**REQUEST FOR ACTION  
CHASKA CITY COUNCIL  
JANUARY 22, 2018**

**Subject: ALDI, Chipotle, Starbucks in Hazeltine Plaza - Concept Plan**

Case No.: PC No. 18-01

Synopsis: The applicant is requesting approval of a concept plan to construct a new ALDI, Chipotle and Starbucks on Lot 1, Block 1 of Hazeltine Plaza

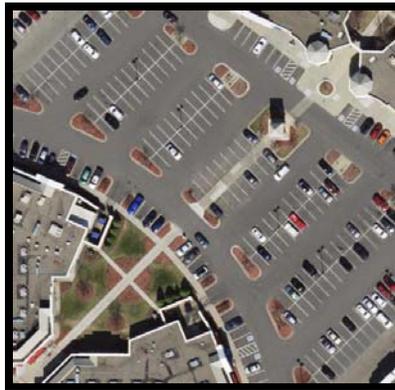
Staff’s recommendations for pedestrian connections can be seen in the following marked-up exhibit and described in the paragraphs below that. These recommendations are to reinforce the statement and intent of this zoning district in creating a “pedestrian-friendly” retail center.

Currently the site plan is not showing a pedestrian connection on the west side to connect to the trail along Highway 41. Staff would advise a connection here; perhaps a sidewalk to tie into the sidewalk just north of the ALDI store. This will provide adequate pedestrian flow for the site, which would also stay in line with the PCD-15’s intent of creating a pedestrian-friendly retail center.

To further achieve the intent of this development, staff would advise the applicant to provide a pedestrian connection into the Starbucks site from the private drive. The sidewalk currently cuts off at the private drive and does not provide an east-west connection into the site. Staff would request this connection be made, and done so in a safe and clear manner since it would be crossing the drive-thru lane.

Another missed pedestrian connection is between the three establishments in the center of the site. Although the center of the site is a parking lot, it would be beneficial to provide a safe and clear connection point between the three establishments. This could be done by providing different colored concrete to delineate this thoroughfare. Parking spaces could also be converted to a refuge point in this pedestrian connection; much like what you see in Chaska Commons seen below.

11. Provision to re-evaluate the location of Chipotle's outdoor patio to the north end of the building near the existing oak trees.
12. Provision of an east-west pedestrian connection between Starbucks and the sidewalk along the private drive.

13. Provision of a pedestrian connection in the center of the site between ALDI and Chipotle's site.
14. Provision of a east-west pedestrian connection on the west side of the site to connect to the public trail on Highway 41.
